Submittal

Date: February 9, 2015
 Project: Shrewsbury STP 1443 (44)

Copies	CCI Submittal Number	Specification Section	Description
Electronic	2	652.10	Erosion Prevention and Sediment Control Plan

DRAWING: EP-3 Construction Conditions
 Erosion Control Plan

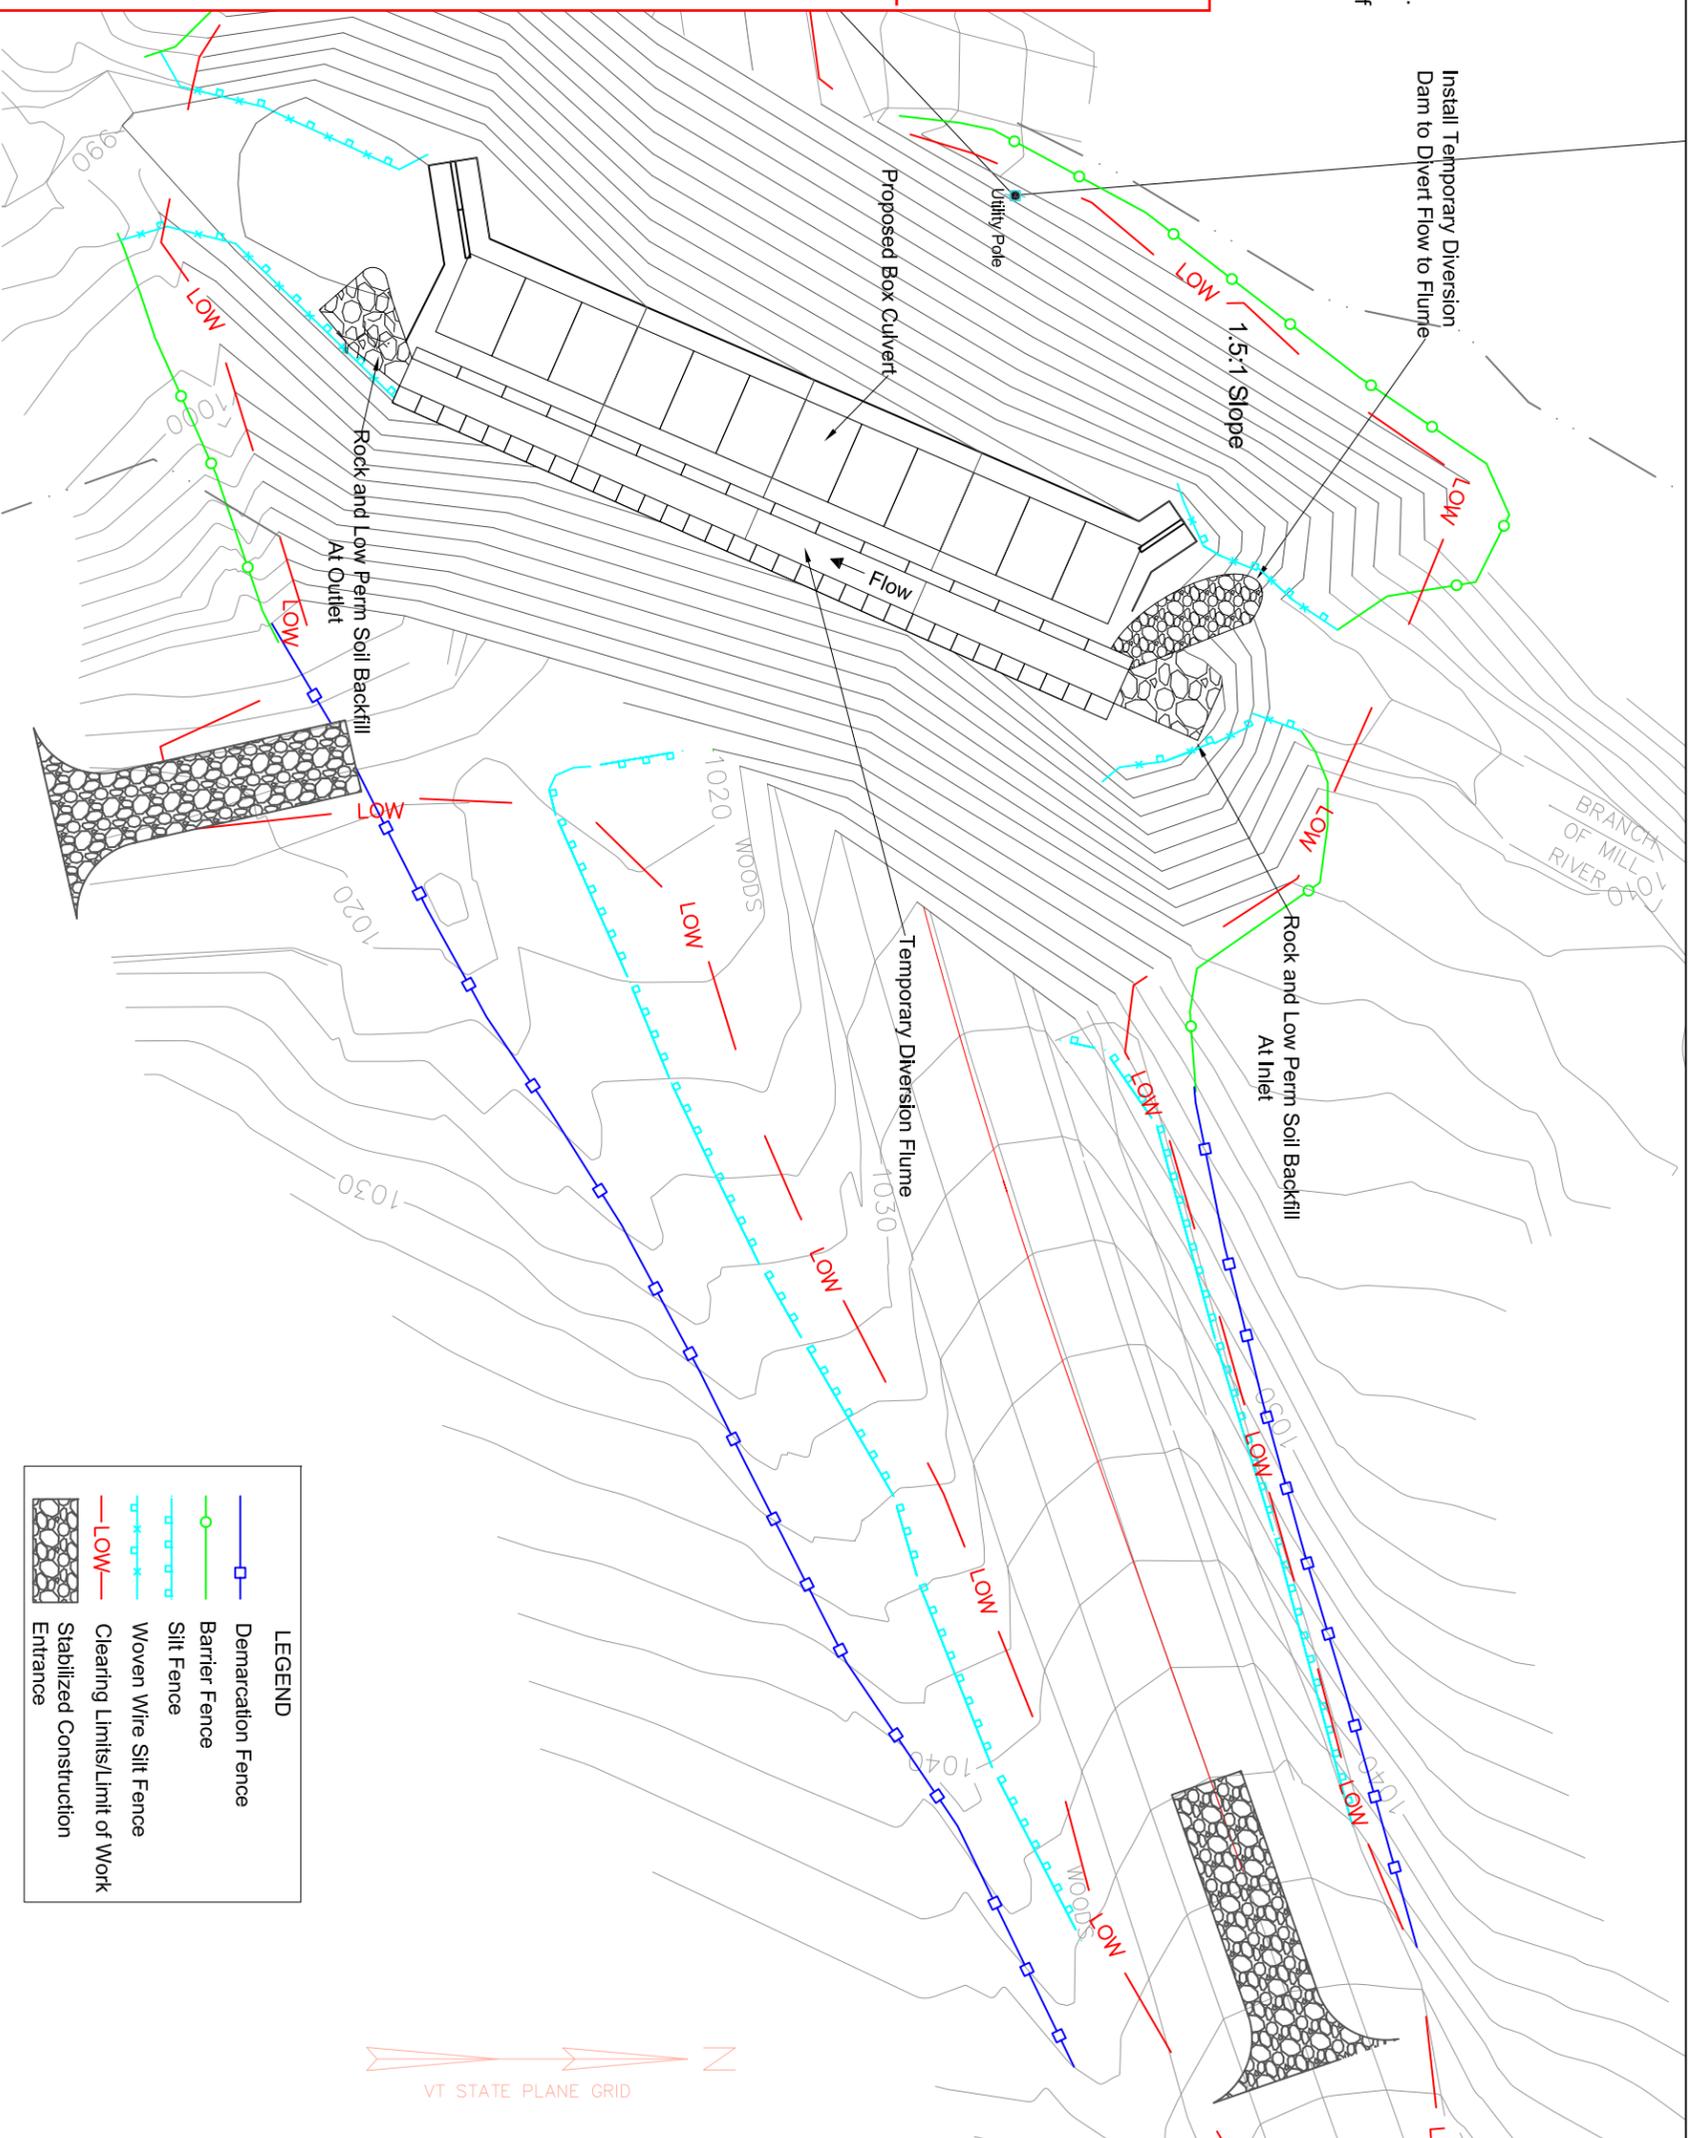
-include roadway and channel alignment stationing

-provide details of what your flume will be made of.

-provide a cross-section of stream diversion system and proposed box culvert to show that there is enough clearance for the arch footing.

-due to the depth of excavation for the footings when the stream diversion is removed how will you keep the stream from flowing into the wingwall footing excavation. Perhaps show another layout sheet and x-section representing that sequence.

-what is the capacity of your stream diversion system? Will it have the ability to overtop should flows become too much for the system? Refer to the Stream Relocation special provision.

-You may need to dewater. You will be 8' below OHW to bottom of footing. If so where will you pump to and how will you treat the water?

-The outlet of the stream diversion will either need to be far enough away from the winnwall excavation as to not back flow into the excavation or there will need to be additional measures detailed in the plan to keep water out of the excavation.

-the silt fence shouldn't cross contours

-the silt fence should be drawn to show which side to install posts. downhill side

-Barrier Fence and Woven Wire Silt Fence are to be used when within 100 feet of waters of the state.
